DWR Questions dated October 1, 2026

USACE Questions dated October 2, 2026

WRC Permitting Comments, October 2, 2026

NC DEPARTMENT OF TRANSPORTATION
DIVISION OF HIGHWAYS
OCTOBER 2026
HENDERSON COUNTY
18314.1045039
GERTON HWY - US 74

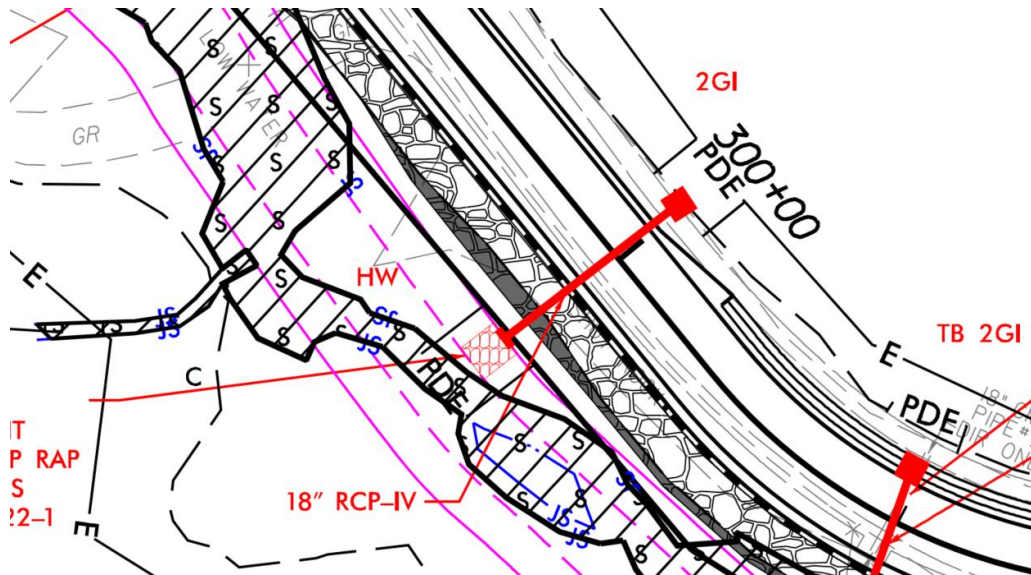
6. Site 9 – The channel realignment results in a long, straightened reach of Hickory Creek. Is there an alternative available?

The grade of the stream slope is very steep in this location and results in more of a Type B stream. In addition, the stream is adjacent to the fill slope of the road. The road is approximately 40 feet higher than the stream. As shown on the plans, the stream washed out the fill and therefore this section of road during Hurricane Helene. While the plans depict a straight reach, it is expected that adjustments will be made during construction, including the use of large boulders to deflect the flow back and forth within the channel footprint.

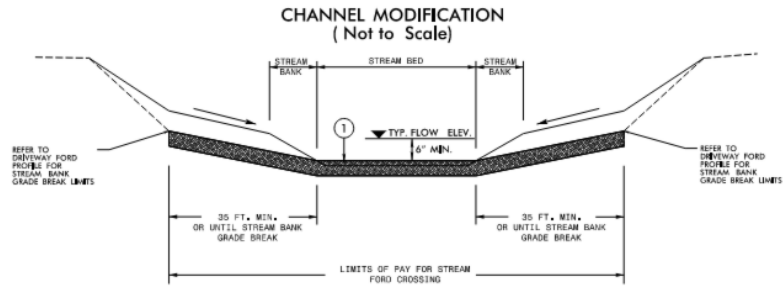
9. Site 12- end of channel realignment – don't see a defined channel that the new channel will connect to (downstream channel is really wide) – will channel be reworked here to a stable dimension?

The contractor and on-site stream relocation professional will need to determine the best location to tie the proposed stream back to the existing stream. The contractor will work in the dry to the extent practicable.

FORD STREAM PROFILE

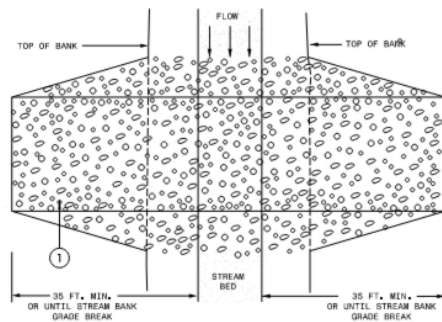
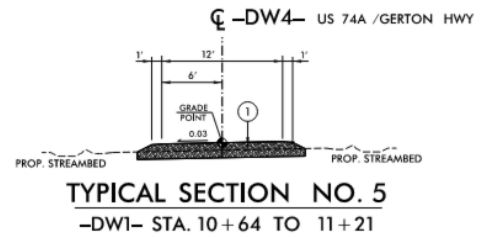
- a. Will a detail be provided for the potential ford in Hickory Creek?

Due to impacting landowners' access to their property, NCDOT will construct/reconstruct rock fords to reestablish this access. The locations and designs of the fords will be provided in a future construction revision. Future maintenance of these fords will be the responsibility of the property owner.

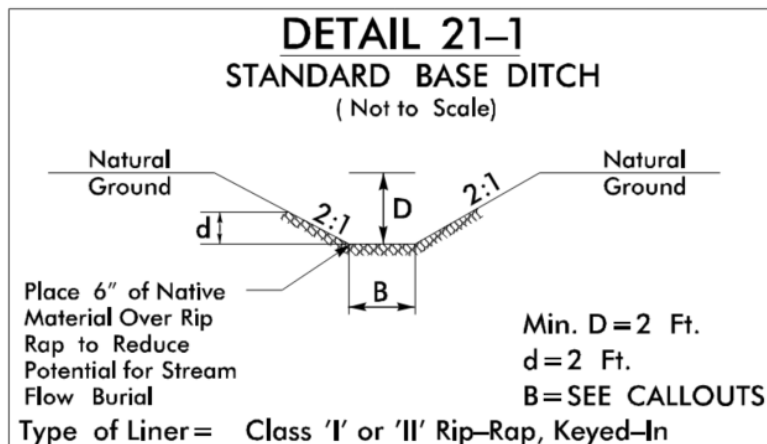
11. Site 20 & 21 – inlet base ditch detail has liner of rip rap with native material on top – this is great.

- The channel changes below, shown with detail Y, Z, B1, C1, D1, E1, do not specify native material on top – can this be specified so that the potential for stream flow burial is reduced?

“Native material” will be added on top of rip rap as noted where practicable.

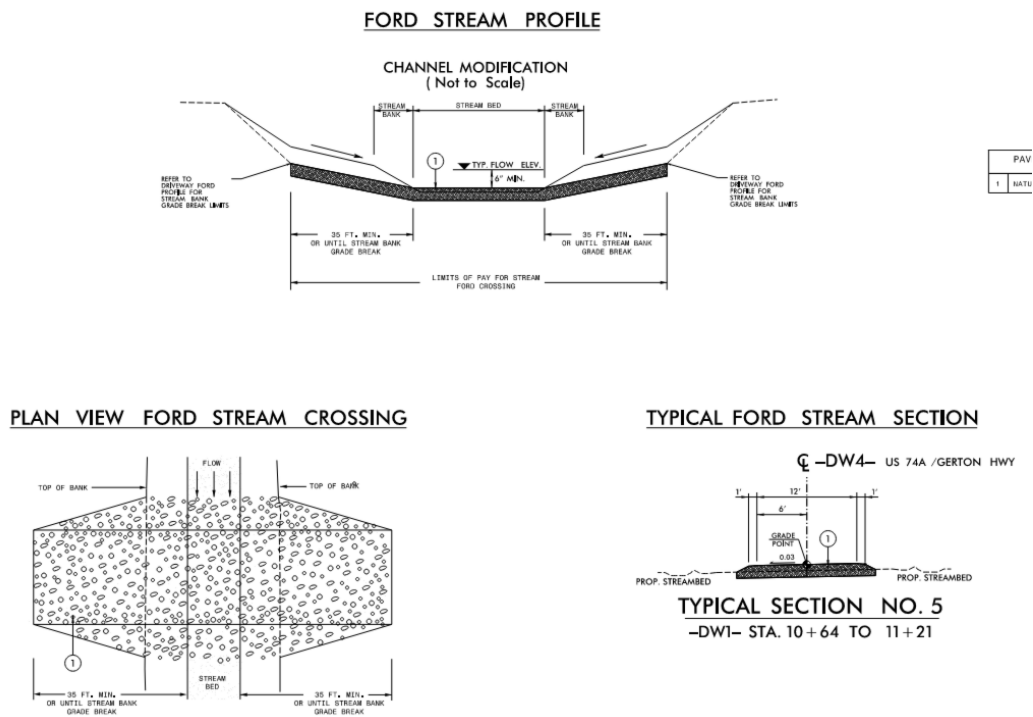
- Sheet 13 of 29 - Why is this stream being relocated when it is so far from the road? –

In this location the road is approximately 62 feet higher than the stream, as shown on the topo Sheet 14, and the slope is extremely steep as shown in the picture. In addition to the near proximity, the channel is also in a bend. During Hurricane Helene this created a scour of the fill slope and subsequent road failure. Consequently, the stream channel will be reestablished further from the roadway, providing a more gradual slope on the embankment.

PERMIT DRAWING
SHEET 2 OF 29

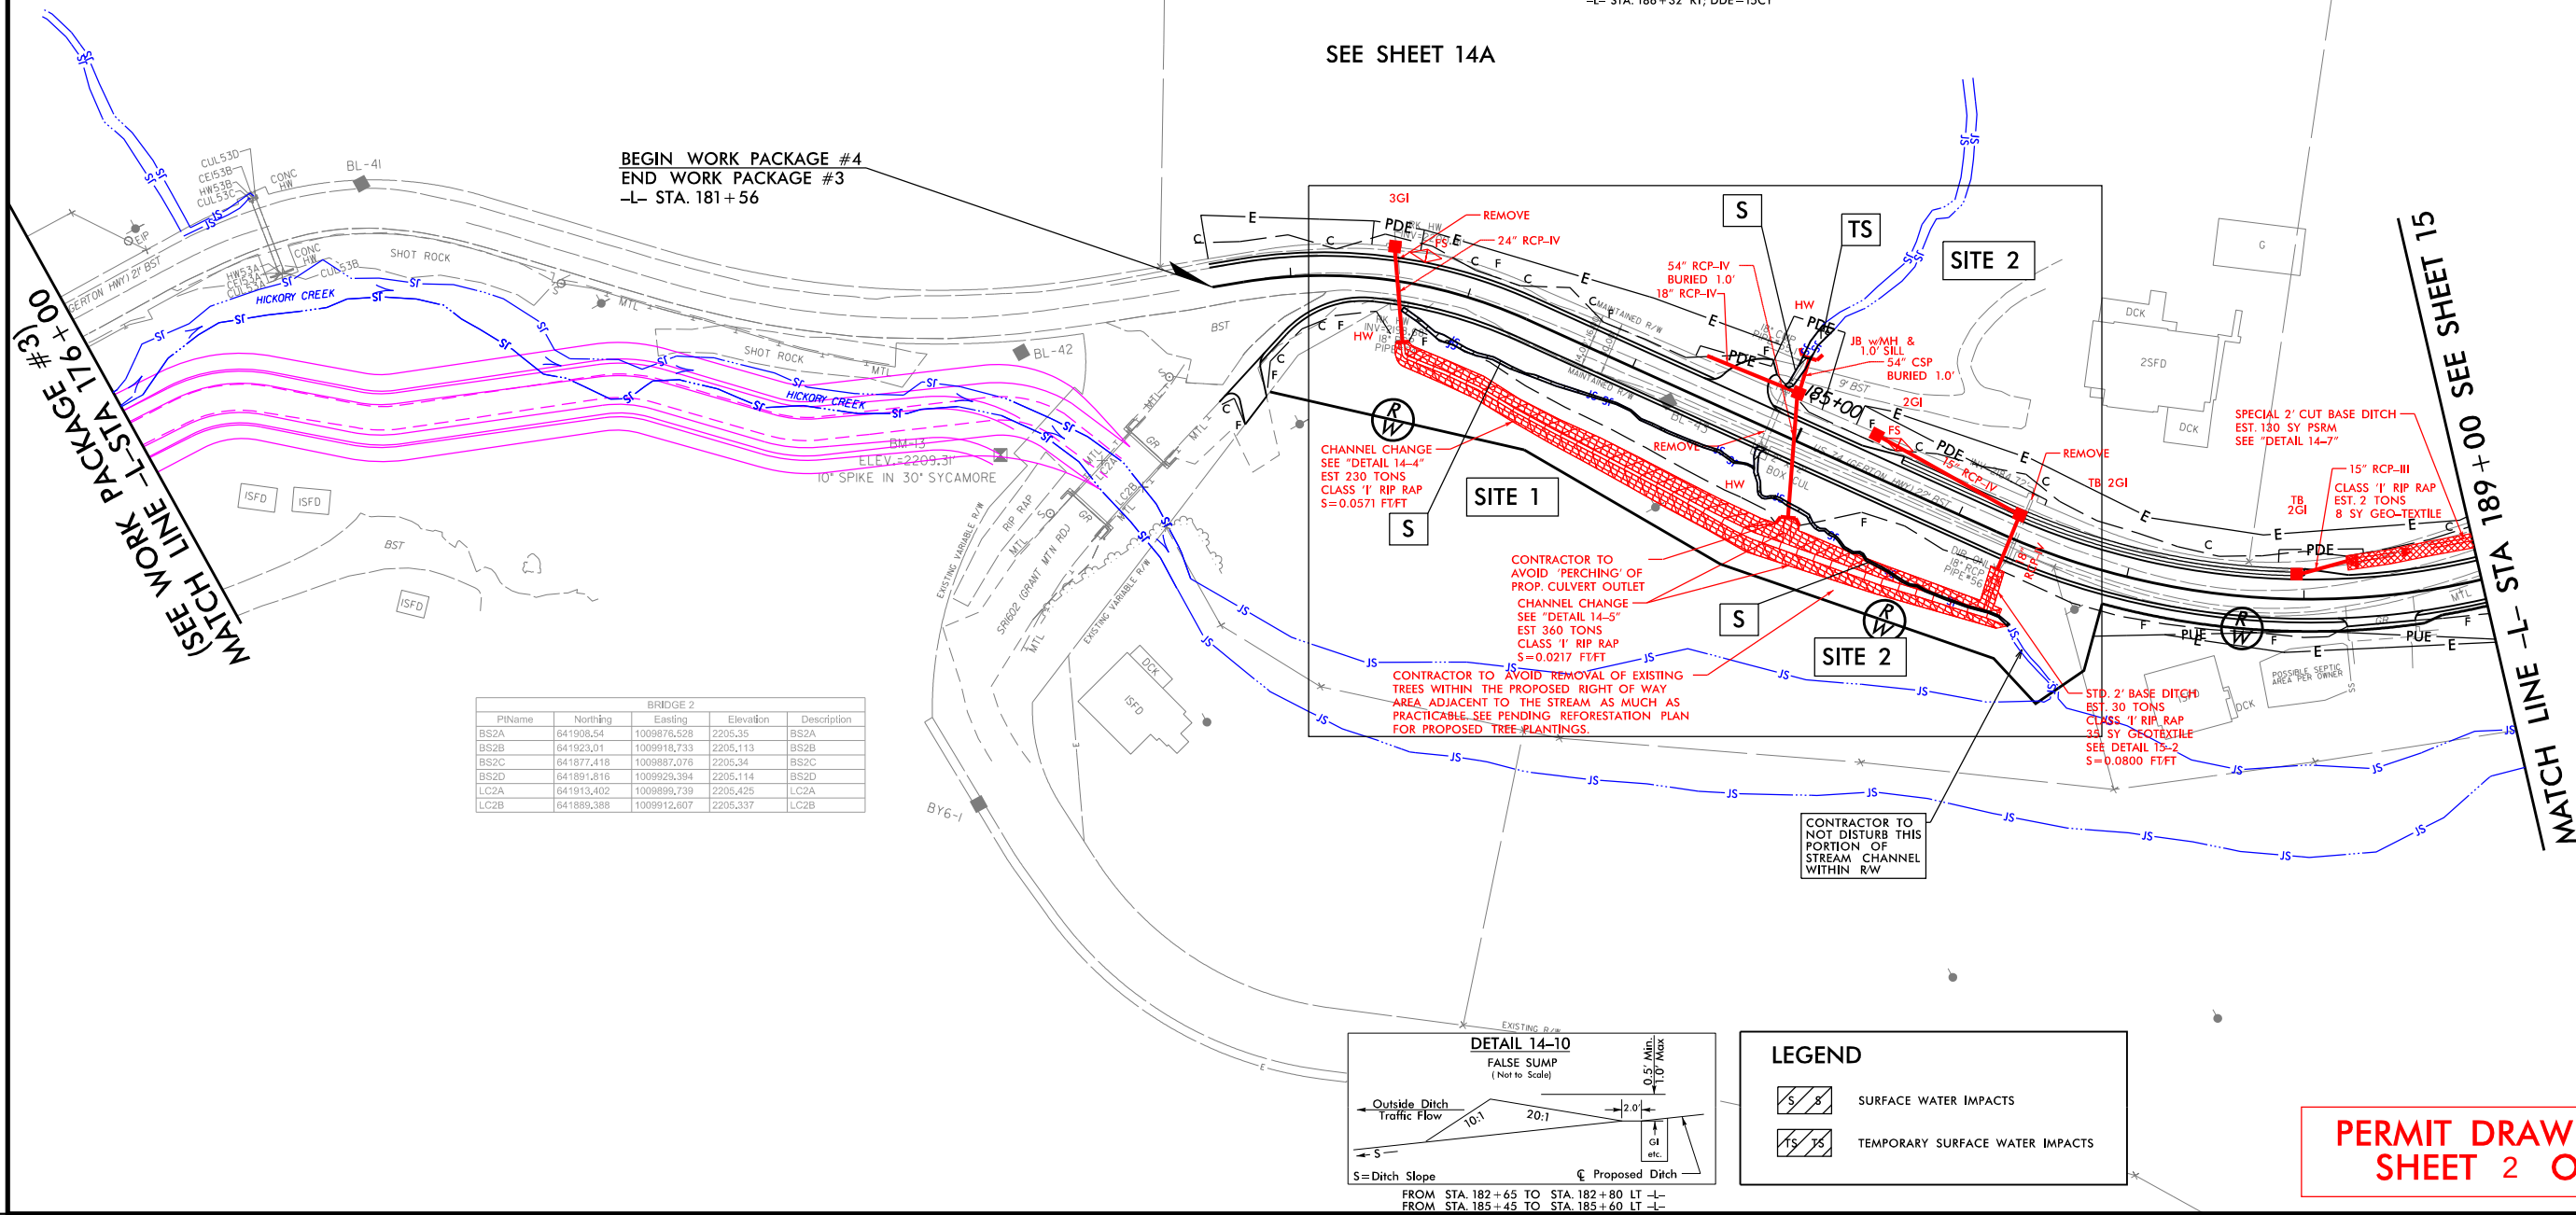
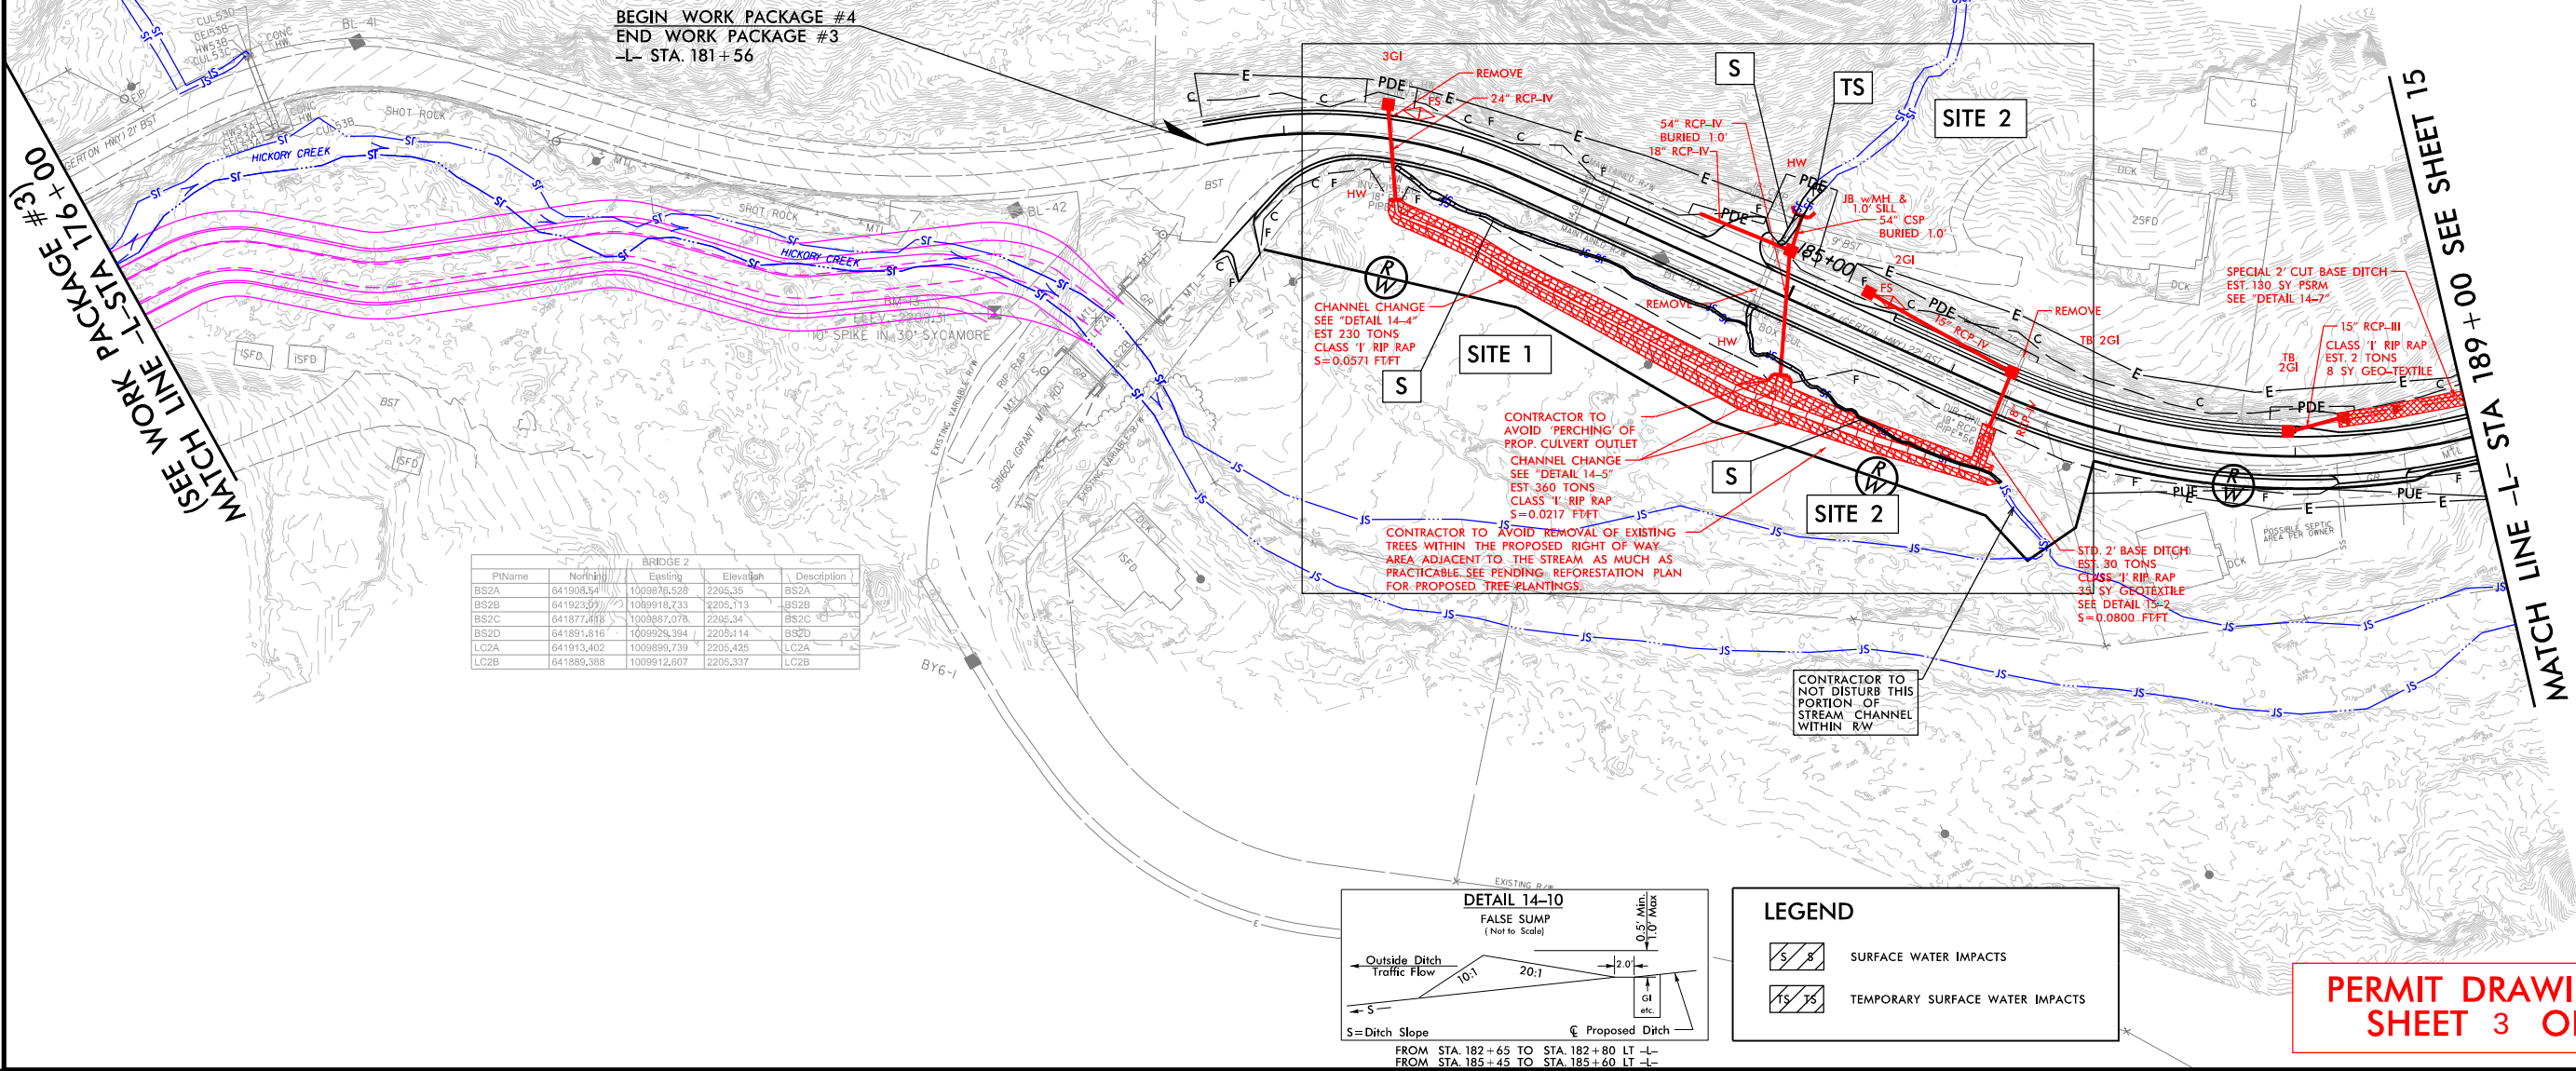
1. Site 2 - UT Hickory Creek channel change (site 2) is oriented at a right angle to the confluence with UT Hickory Creek (Site 1 channel change) – can this angle be altered so it is not perpendicular to the streambank?

- Sheet 4 of 29 - This angle should be softened so it's not a 90 degree turn. -

The angle has been altered on the drawings to approximately 75-degrees (heading downstream) with the receiving channel flow. Additionally, impacts have been reduced by 30 lf of permanent impacts, and 15 lf of temporary impacts.

Site 2:
Adjusting for a better angle into UT, and
reducing permanent impact by 30 lf and
temporary by 15 lf.

Site 2:
Adjusting for a better angle into UT, and
reducing permanent impact by 30 lf and
temporary by 15 lf.
